Conceptual Design Guidelines for Posen Ave. Landscaping
(see attached figure for zones).

Proposed Planting and Streetscape Improvements

Saint Mary's College High School

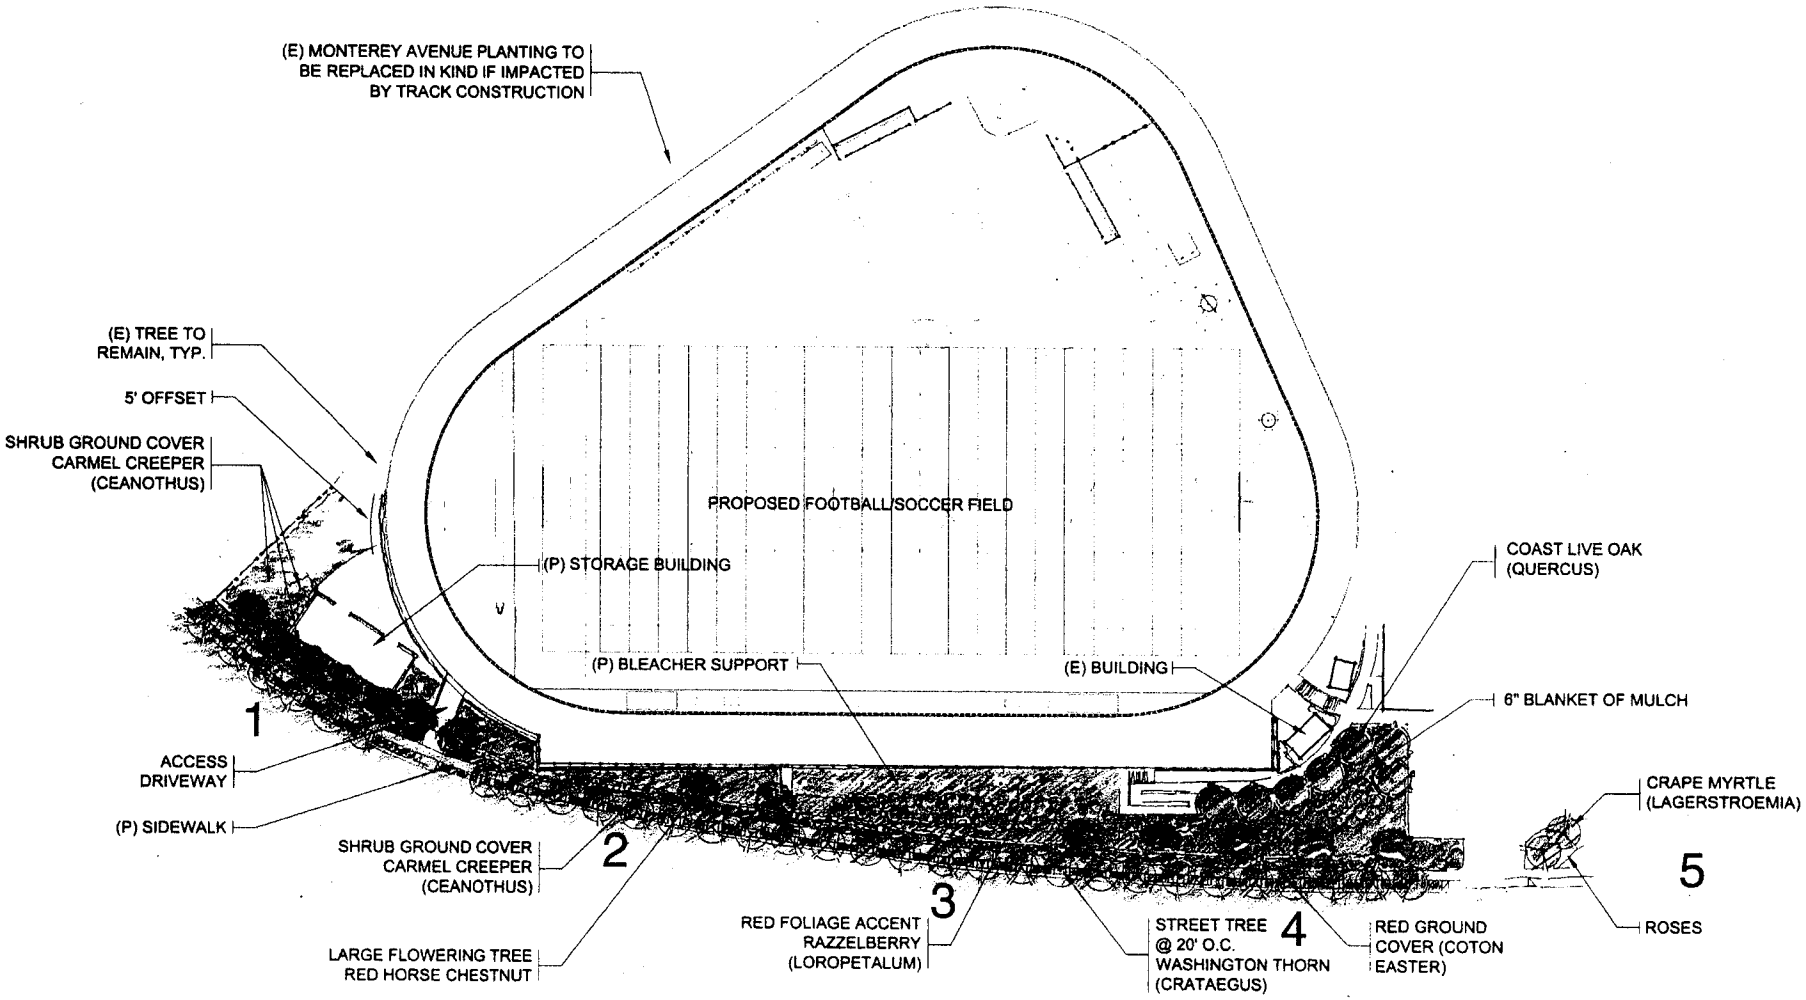
Zone 1 (east posen gate to Leni Siegel's house):
- Besides trees shown on plans, also need mid-sized shrubs to screen storage building from street.

Zone 2 (east posen gate to bleachers)
- Shrubs should be high enough to screen retaining wall for track.

Zone 3 (bleachers)
- Because bleachers will be more "solid" than originally thought, landscaping should screen backside of bleachers as much as possible.
- Shrubs on hillside should be all enough to screen bleacher support structure.
- Planting should be layered to enhance screening.
- Add vertical plantings to break up horizontal mass of bleachers.

Zone 4 (bleachers to west posen gate)
- Shrubs in this area should be tall enough to screen the bleacher access ramp
- Westmost two pittosporum trees should be changed to a taller species, to help screen gym
- Also need some shrubs (6-8' tall) to help screen view into parking lot (vans and vending machines)

Zone 5 (west posen gate to property line)
- Need to continue landscaping plan westward through this zone.
- Eucalyptus stump next to main pedestrian gate should be replaced with tall (50'+) tree

General:
- Street trees should be non-deciduous and staked strongly enough to protect from car doors
- Posen landscaping along the track should have 2-3 taller trees (50') along its length to help break up view into the playing field for neighbors uphill (e.g., Beverly place)
